Report FL #: 10088 for Greenheck models EHH-601D & ESD-635D (both w/ and w/o VCD-40 Damper)

Report FL #: 10093 for Airolite models SCH601MD & K6746MD (both w/ and w/o VCD-40 Damper)

NOTICE OF ACCEPTANCE (NOA)

APPROVAL DOCUMENT: Drawing No. **EHH-601D**, titled "EHH-601D Louver", sheets 1 through 35 of 35, dated 08/09/2017, prepared by Greenheck Fan Corporation, signed and sealed by Wayne K. Helmila, P.E. on 09/27/2024, bearing the Miami-Dade County Product Control revision stamp with the Notice of Acceptance number and expiration date by the Miami-Dade County Product Control Section.

22A
19 MULLION DETAIL W/ VCD-40
LOUVER HEIGHT ≤ 144 IN.
FLANGE FRAME SLEEVE MOUNT

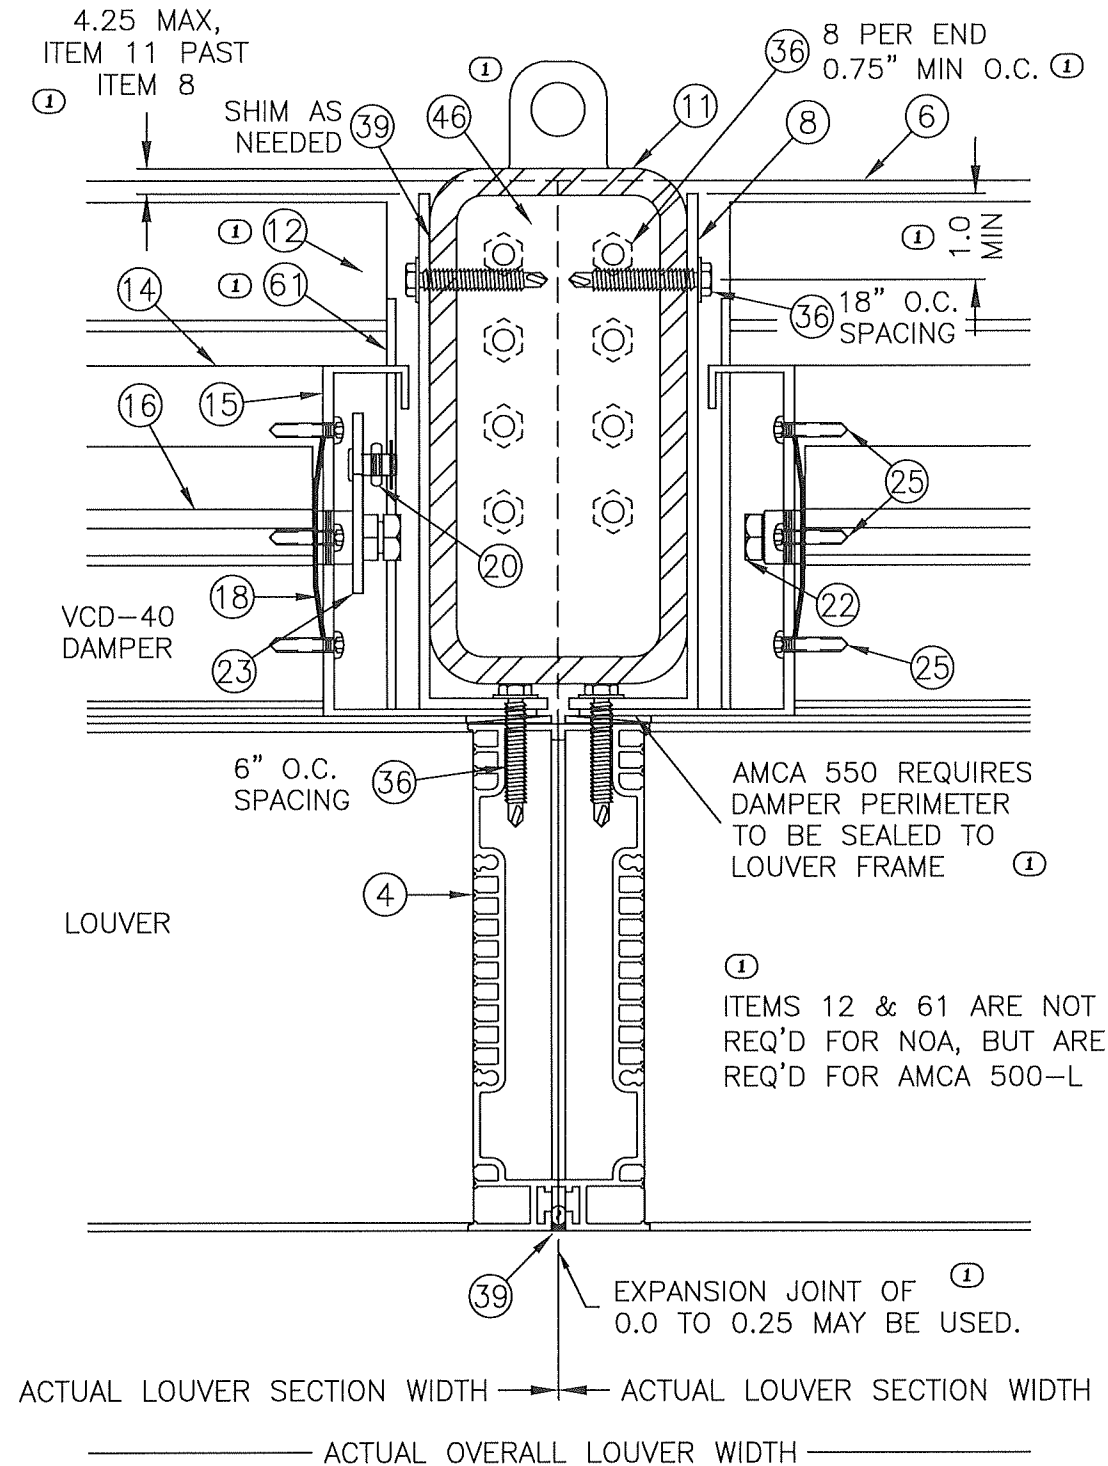
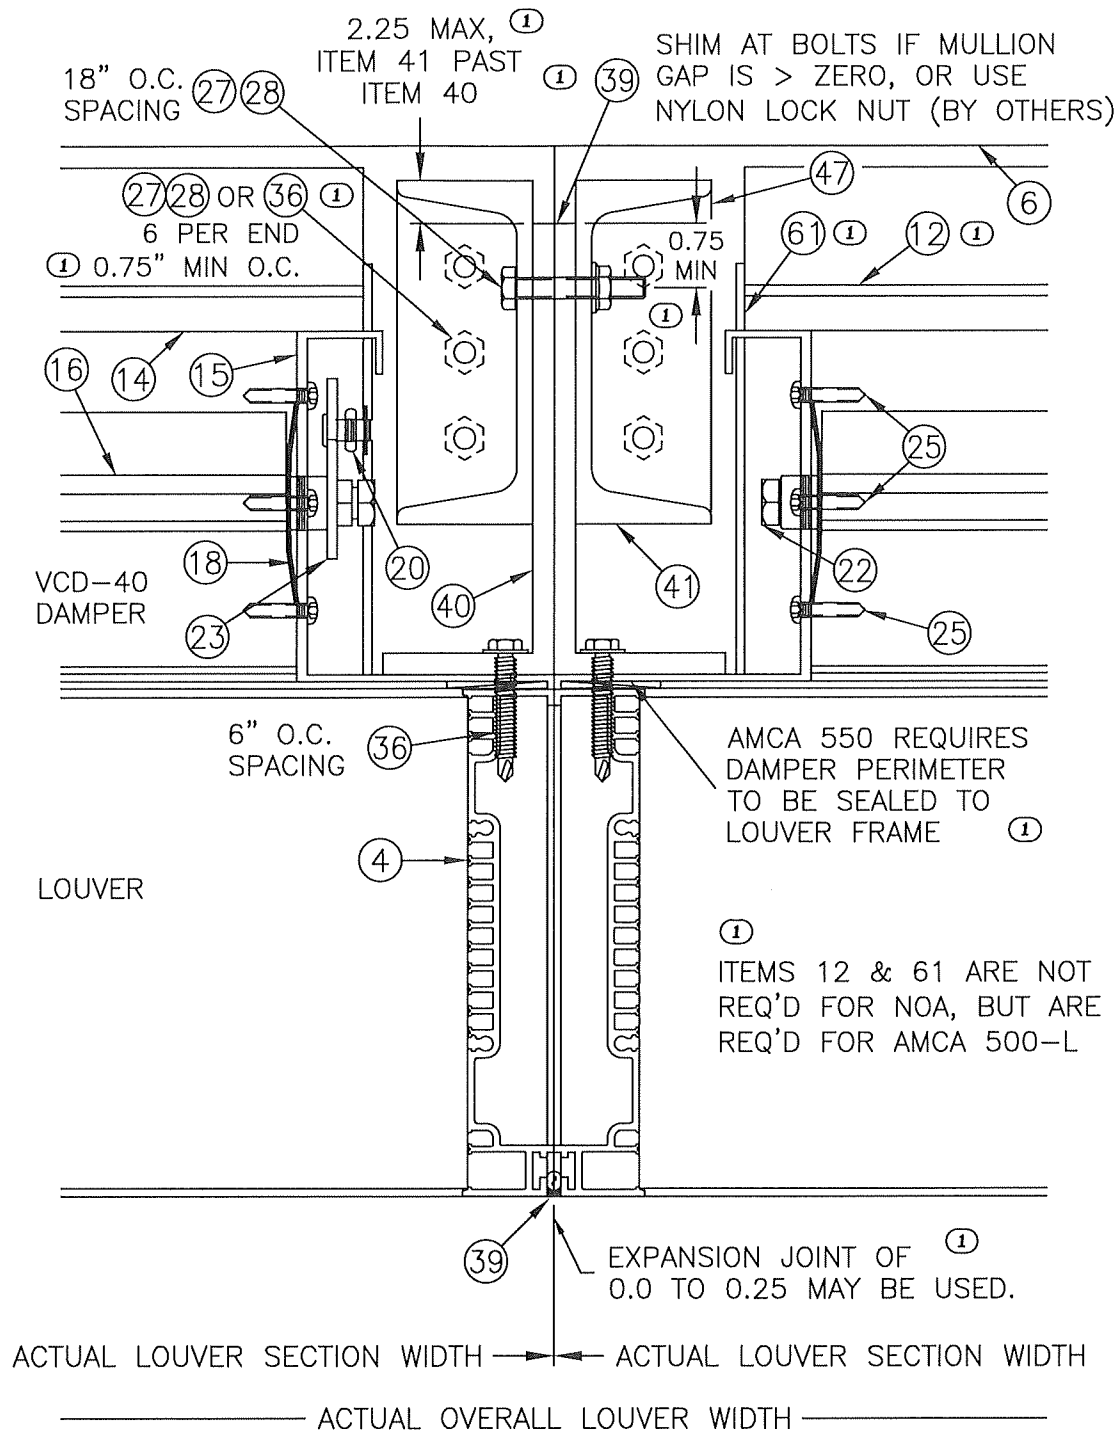
REV 01: 8/1/24, MOVED ITEMS 22A&B TO THIS NEW PAGE, REDEFINED ITEM 11 & 41 OFFSETS, ADDED 1.0 & 0.75 MIN OFFSETS, ADDED LUG TO ITEM 11, ADDED ITEM 39 CALLOUT & NOTE, ADDED MIN O.C. FOR ITEM 36 X2, REWORDED MULLION GAP NOTE X2, ADDED ITEM 12 WITH NOTE X2, ADDED ITEM 36 OPTION, ADDED ITEM 61 X4 & ITS CALLOUT X2, & ADDED AMCA 550 NOTE X2.

23
20 JAMB DETAIL W/ VCD-40
LOUVER HEIGHT ≤ 144 IN.
CONTINUOUS ANGLE MOUNT

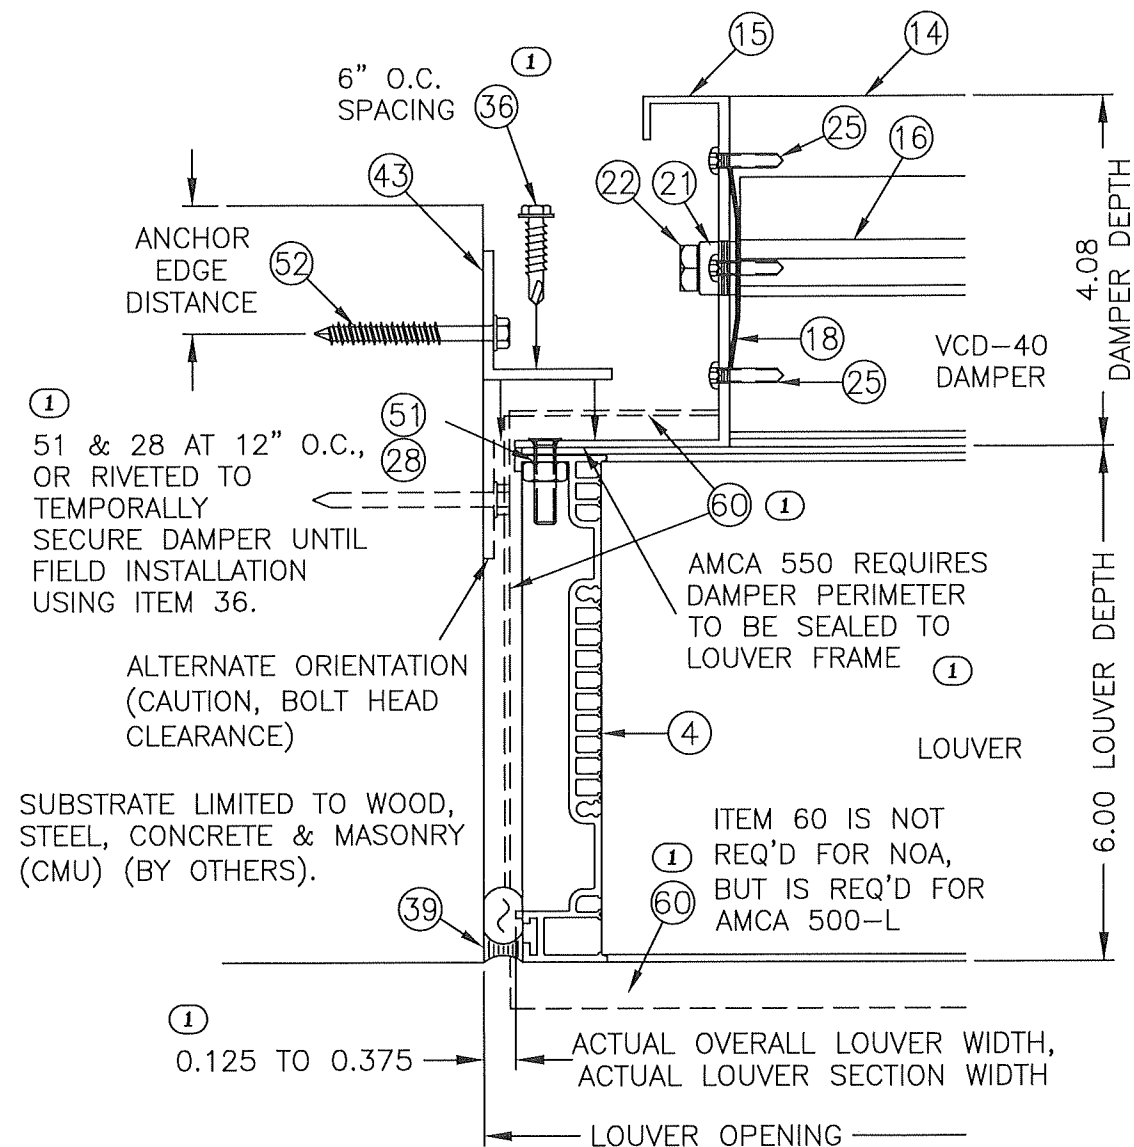
REV 01: 8/1/24, WAS PAGE 16, MOVED DETAILS 24A&B TO A NEW PAGE, REPLACED ITEM 37 WITH ITEM 36, ADDED DAMPER RIVET ATTACHMENT NOTE, REMOVED "TYP" FROM EDGE GAP, ADDED ITEM 60 X2 & ITS NOTE, & ADDED AMCA 550 NOTE.

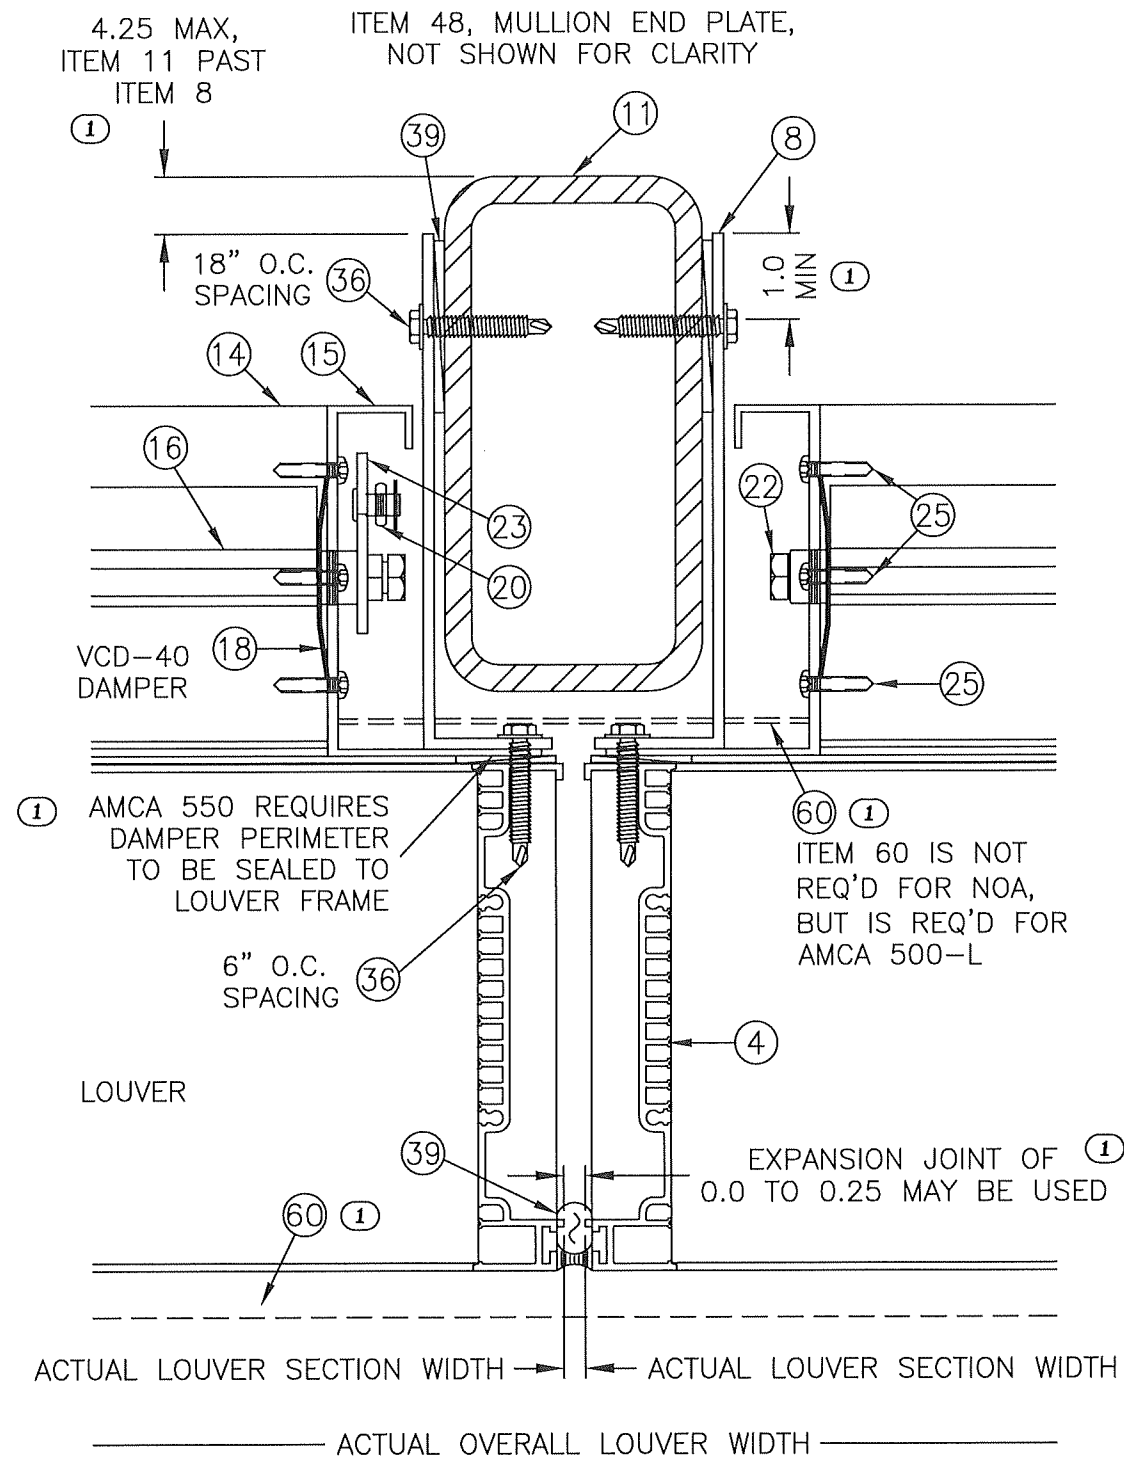
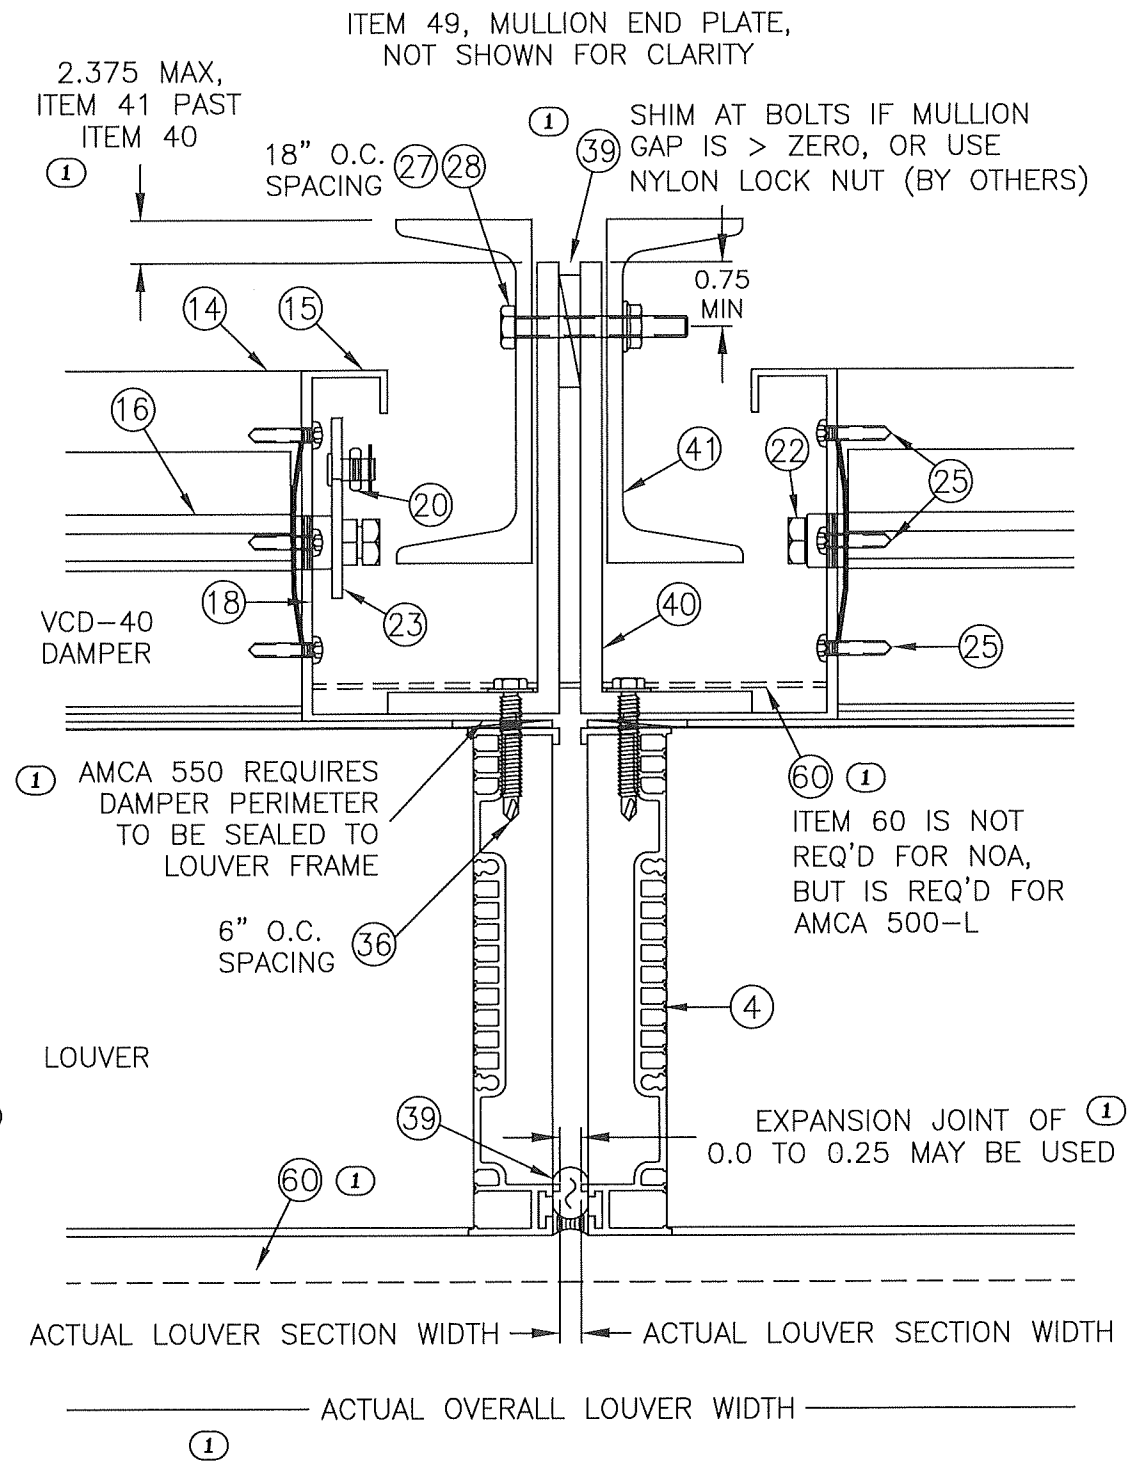
REV 01: 8/1/24, MOVED DETAIL 24A&B TO THIS NEW PAGE, REDEFINED
ITEM 11 & 41 MAX OFFSETS, ADDED 1.0 & 0.75 MIN OFFSETS,
REWORDED MULLION GAP NOTE X2, ADDED ITEM 39 & NOTE, ADDED
ITEM 60 X4 & ITS NOTE X2, & ADDED AMCA 550 NOTE X2.
